PCN No#: 071521-1

PCN Title: Additional new lead frame for SOT-523 Package

PRODUCT CHANGE NOTICE

Table A - Lead frame comparison and marking code comparison		
	Old	New
Lead Frame (Example: MMBT2222AT-TP)		
Marking Code (Example: MMBT2222AT-TP)

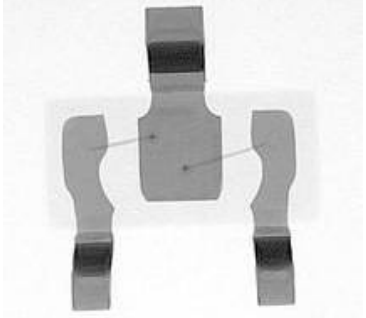
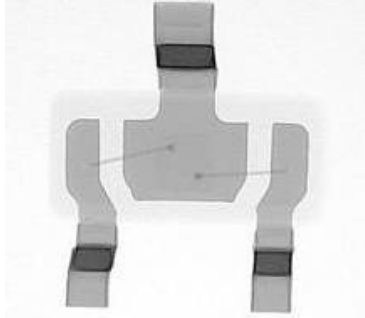
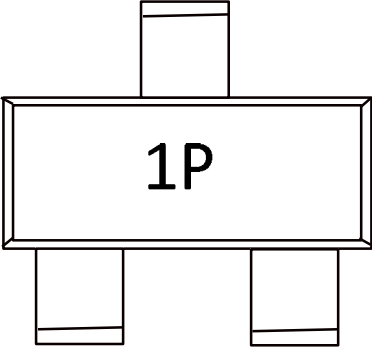
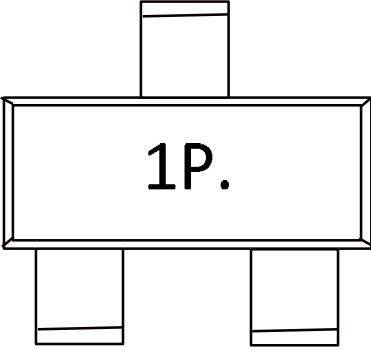
Notification Date	Implementation Date	Last Time Buy Ship Date	Change Type	PCN No
Jul 15, 2021	ASAP	N/A	Additional new lead frame	071521-1
TITLE				
Additional new lead frame for SOT-523 Package				
DESCRIPTION OF CHANGE				
To make our lead frame more compatible of different part structures, MCC will add a new design of lead frame for SOT-523, this change will not affect any reliability of the parts and there is no need to make any adjust of the solder pad.				
IMPACT				
No change in datasheet electrical parameters and product performance. Table A: Lead frame comparison and marking code comparison.				
PRODUCTS AFFECTED				
Table 1: Affected Parts List				
WEB LINKS				
Terms And Conditions:	https://www.mccsemi.com/Home/TermsAndConditions			
For More Information Contact:	https://www.mccsemi.com/Contact/Index			
Products:	https://www.mccsemi.com/ProductCategories			
DISCLAIMER				
Unless a MCC Sales representative is contacted in writing within 30 days of the posting of this notice, all changes described in this announcement are considered approved.
